LOCAL HISTORIC DISTRICT: Wilmore

PROPERTY ADDRESS: 1751 Merriman Avenue

SUMMARY OF REQUEST: Non-traditional materials

HDC-2019-00157

Front Elevations
(no change)

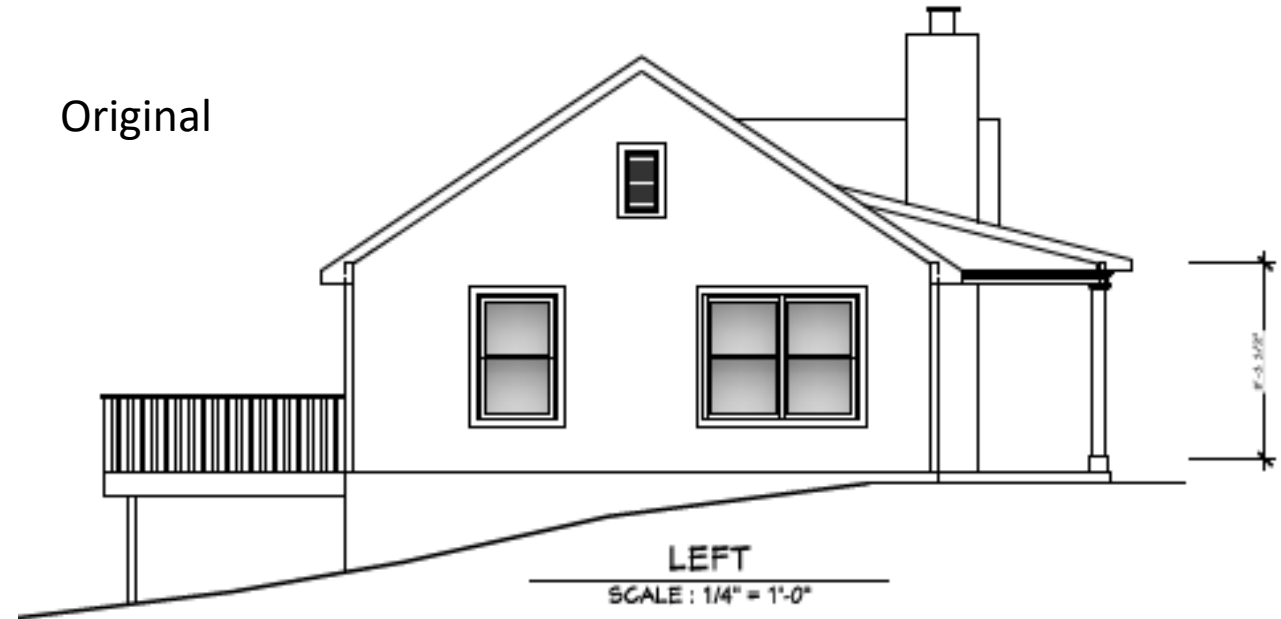
Siding will be Nichiha Smooth: fiber cement through the addition and the existing structure.
7.25"

Painted brick foundation to match current painted brick

Current gutters will be extended on addition to match

Rear elevations: existing and proposed

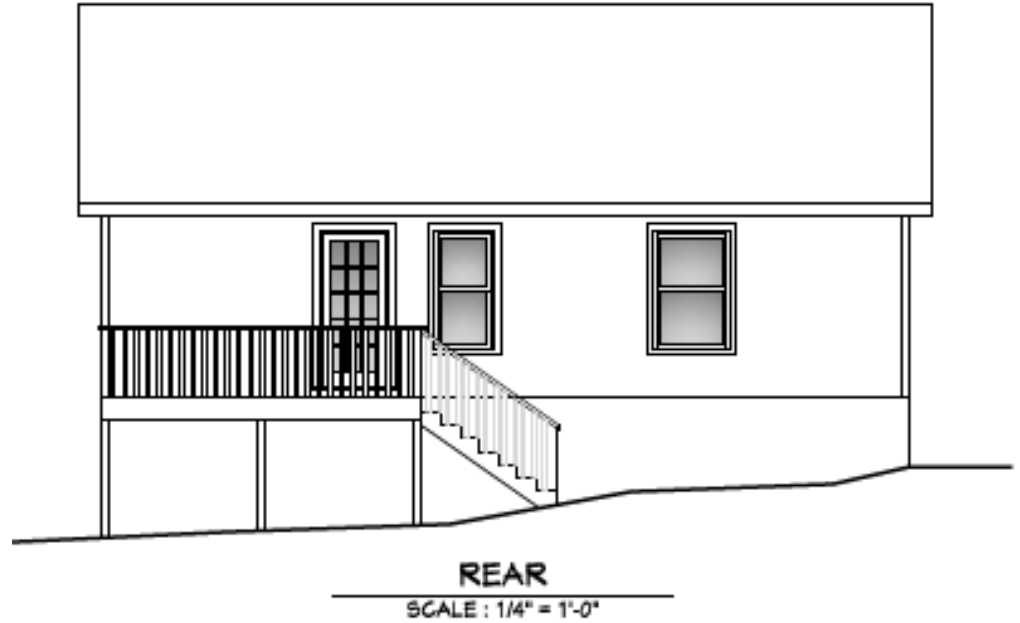
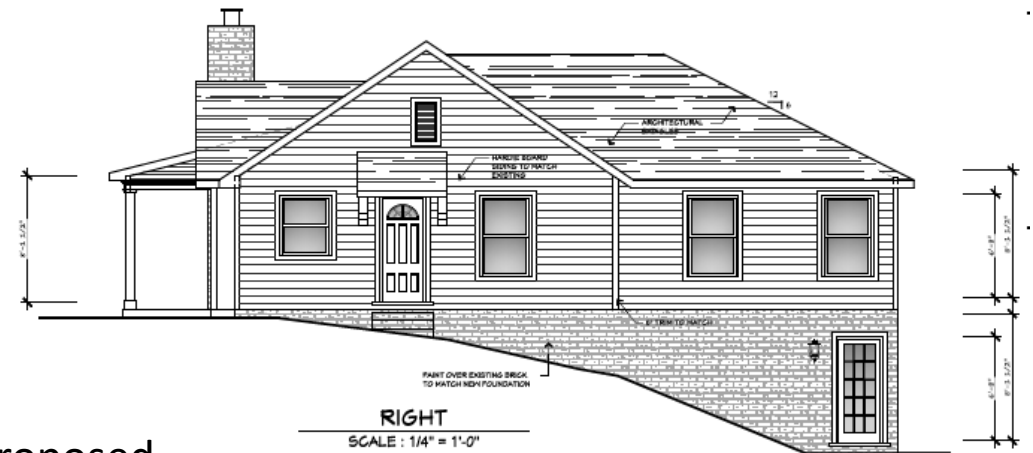
Is it possible to have the siding approved to also be just below the window and matching along the side ?

Driveway

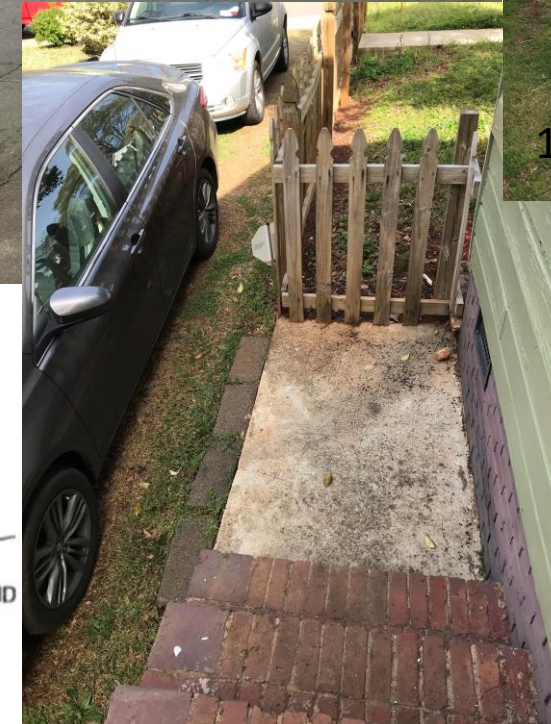
Red is proposed concrete,
green is proposed garden.

My current driveway is on my neighbors yard. They have asked me not to put concrete down on their property. I am proposing a driveway that would be 18 ft of concrete and two feet of decorative pavers/rock with me cutting down a fence and shortening the existing sidewalk. The way my porch stairs and existing concrete are on my house is shown above.
